Access Compliance Report

Public Rights-of-Way

(Curb Ramps)

Intersection ID: 10034609	Main Street: PLANTATION_CENTER_DR	Cross Street: N/A	Location: SW
ADA ID: 4420F3F78981	Ramp Type: Para	Initial Pass/Fail: Fail	Overall Compliance: No
Codes/Mitigation Info/Possible Solution		Field Measurements/Component Compliance	
Severity Score: 35

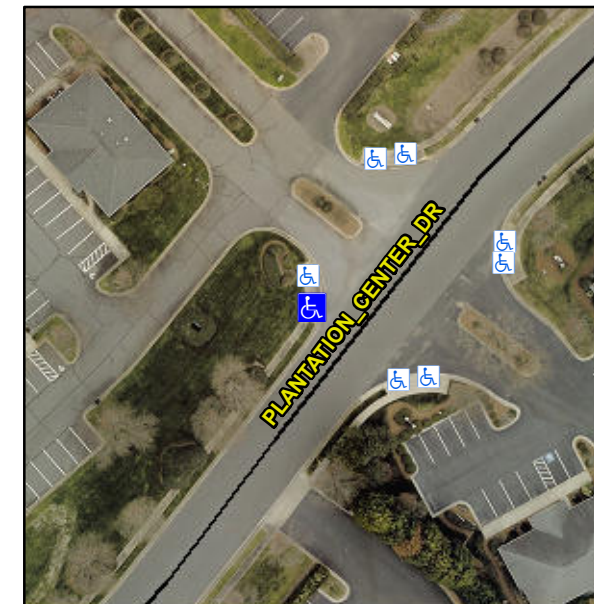
R304.5.1, R304.3.2, R304.5.3

Compliance	Description	Data	Compliance	Description	Data
N/A	Ramp Length LT (in)	60.0	N/A	Ramp Length RT (in)	49.0
No	Ramp Width LT (in)	47.5	Yes	Ramp Width RT (in)	48.0
No	Ramp Slope LT (%)	10.0	No	Ramp Slope RT (%)	14.0
Yes	Ramp XSlope LT (%)	1.7	No	Ramp XSlope RT (%)	2.4
N/A	Landing Length (in)	N/A	N/A	DWS Provided?	N/A
N/A	Landing Width (in)	N/A	N/A	DWS Contrast?	N/A
N/A	Landing Slope (%)	N/A	N/A	DWS Length (in)	N/A
N/A	Landing X Slope (%)	N/A	N/A	DWS Full Width?	N/A
N/A	Landing Curb? (Y/N)	N/A	N/A	DWS Offset (in)	N/A
N/A	Shared Landing?	N/A			
N/A	Gutter Ponding?	N/A	N/A	Gutter Slope (%)	N/A
N/A	Gutter Lip Ht (in)	N/A	N/A	Gutter X Slope (%)	N/A
N/A	Painted X Walk1?	No	N/A	Painted X Walk2?	N/A
	X Walk 1 Direction	To SE		X Walk 2 Direction	N/A
N/A	X Walk 1 Width (in)	N/A	N/A	X Walk 2 Width (in)	N/A
	X Walk 1 Slope (%)	2.7		X Walk 2 Slope (%)	N/A
	X Walk 1 X Slope (%)	0.8		X Walk 2 X Slope (%)	N/A
N/A	Ramp inside XWalk1?	N/A	N/A	Ramp inside XWalk2?	N/A

Remove & Replace Entire Ramp.
